**Contract No. HY/2010/08**  
**Central – Wan Chai Bypass – Tunnel (Slip Road 8 Section)**

**As-Built Drawings of Noise and Visual Mitigation Measures**  
**in the deposited Additional Mitigation Plan for Slip Road 8**  
**(under Condition 2.12 of Environmental Permit No. EP-482/2013/A)**

**As-built Drawings of Noise and Visual Mitigation Measures for Slip Road 8  
under condition 2.12 of EP-482/2013/A**

**As-built Drawings of the Landscape and Visual Mitigation Measures for Slip Road 8**

SKETCH NO. 60095653/72/SK0750

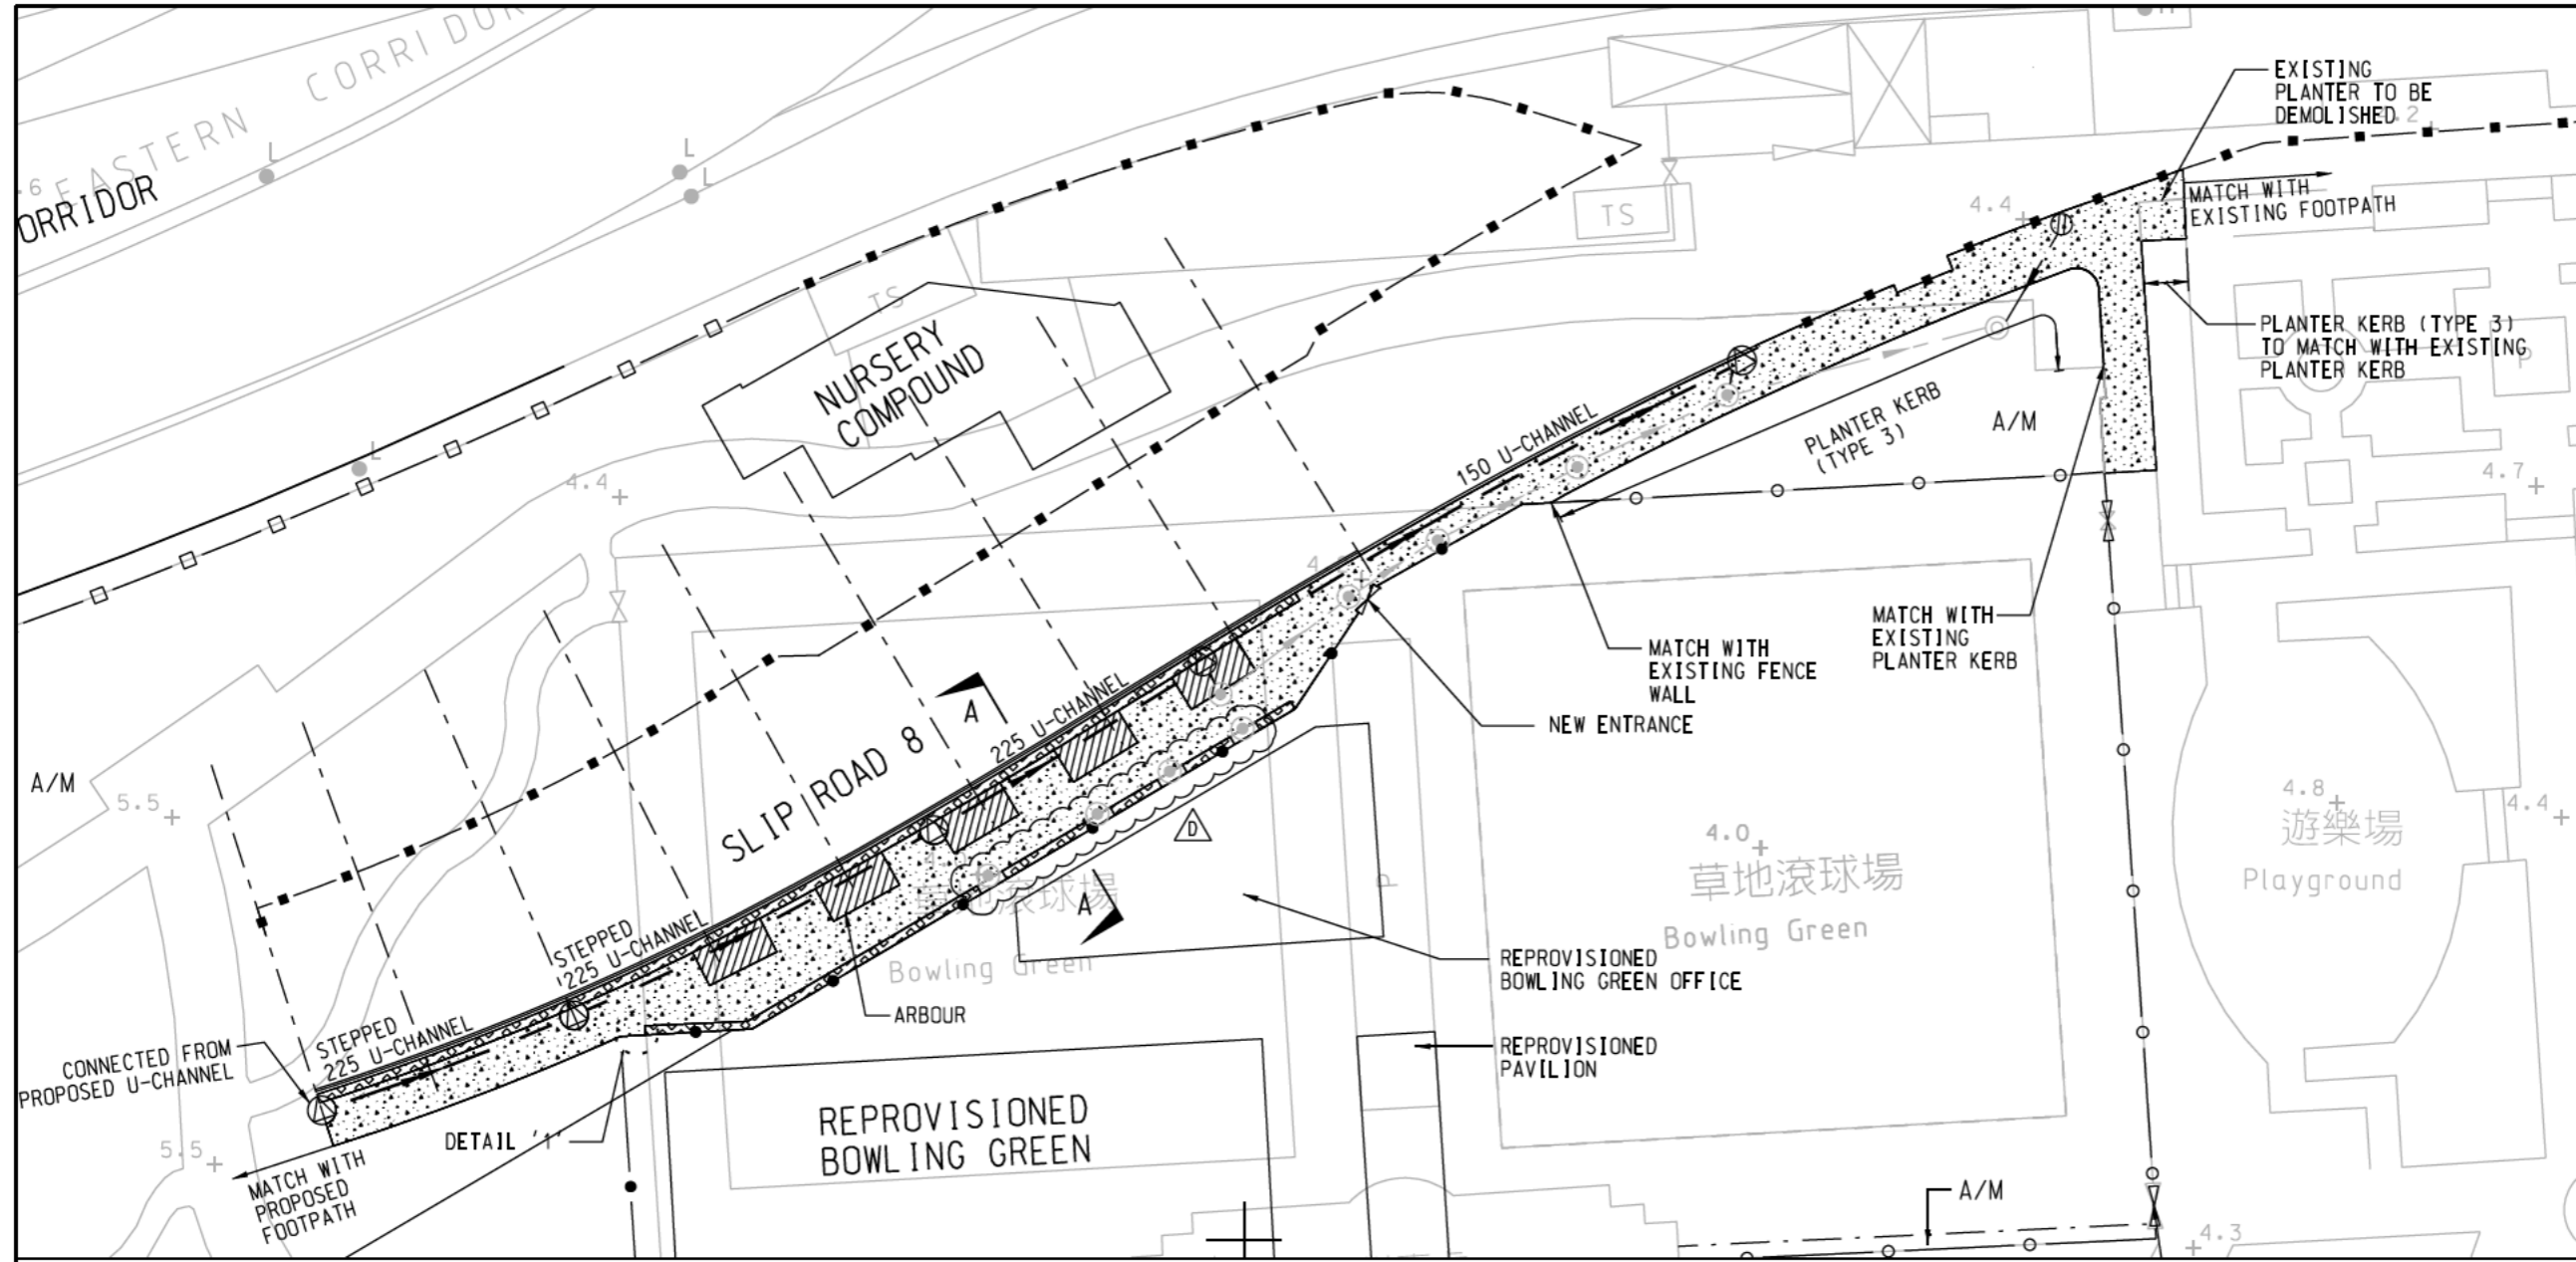
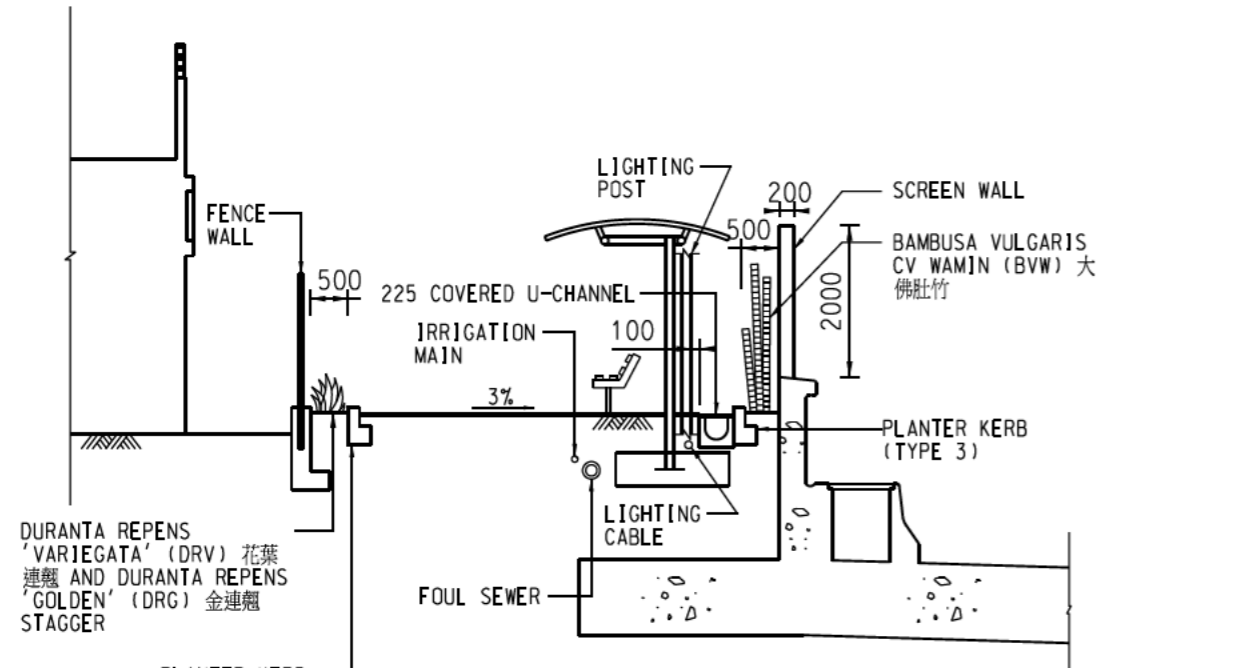
As discussed in the VPMO Meeting yesterday, please advise whether you have any comment on the proposed planting plan for the additional walkway as shown on the attached Sketch No. SK0750.

Please be advised that we have no adverse comment for the proposed planting plan for the additional walkway and the proposed location of 12 nos. transplanting trees.
